SUBJECT: CERTIFICATION OF THE MINUTES OF THE JOINT ACRS
 THERMAL-HYDRAULICS PHENOMENA AND REALIABILITY AND
 PROBABILISTIC RISK ASSESSMENT SUBCOMMITTEES
 MEETINGS, APRIL 5 AND APRIL 18, 2017, IN ROCKVILLE,
 MARYLAND

**ADVISORY COMMITTEE ON REACTOR SAFEGUARDS
THERMAL-HYDRAULICS PHENOMENA AND
RELIABILITY AND PROBABILISTIC RISK ASSESSMENT
JOINT SUBCOMMITTEE MEETING MINUTES
April 5 and 18, 2017
Rockville, MD**

The purpose of this Joint Subcommittee meeting was for South Texas Project Nuclear Operating Company (STPNOC) to present a detailed overview of their revised risk-informed approach to resolve GSI-191, the generic safety issue entitled, “*Assessment of Debris Accumulation on PWR Sump Performance*,” submitted in a license amendment request (LAR) for Units 1 and 2 of the South Texas Project (STP) power plant, and for NRC staff to present a detailed overview of their review and the results of their review of the LAR. The revised approach was submitted to the NRC for docketing in Supplements 2 and 3 to their original submittal in response to Generic Letter 2004-02, “*Potential Impact of Debris Blockage on Emergency Recirculation During Design Basis Accidents at Pressurized-Water Reac

Figure 1. A graphical representation of the categories ($TW_{Cat(D_i^{small})}$) in STP Class 1 pipes showing the categories above the smallest $D_i^{small} = 9.34''$ (Supplement 3).

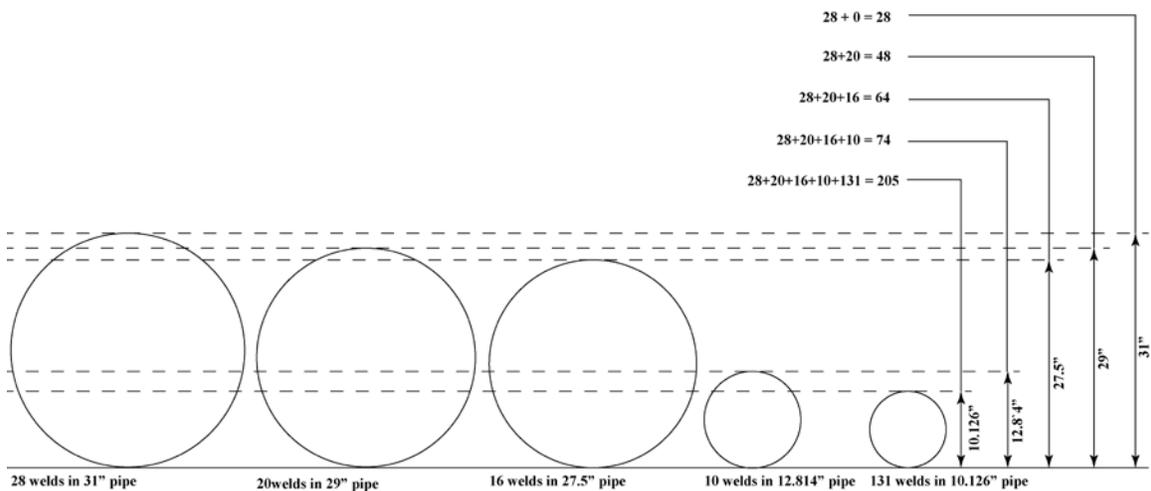
<p>Ernie Kee, STPNOC, discussed the STP response to Question 2: <i>Can STP explain the reason why the ΔCDF decreased for continuum model (Case 2 single train operation) between Supplements #2 and #3 of the LAR?</i></p> <p>ACRS Members were satisfied with the written response and no issues were addressed during this part of the meeting.</p>	<p>34 – 36 Response Pages 3 – 7</p>
Drew Richards, STPNOC, discussed the STP response to Question 3: <i>For the Technical Specifications, what is the Pressure</i>	<p>36 – 37 Response Page 8</p>

that involve discrete pipe sizes. The change in D_i^{small} from Supplement 2 to Supplement 3 brought in a different pipe size (weld category.) A detailed inspection of intermediate results is provided in the following.

Because pipe sizes are built in discontinuous diameters, the potential for a break at any size will inherently reflect this discontinuity. Figure 1 is an illustration of how the $Cat(D_i^{small})$ are formulated for the extent of break sizes relevant to the Case 2 results.
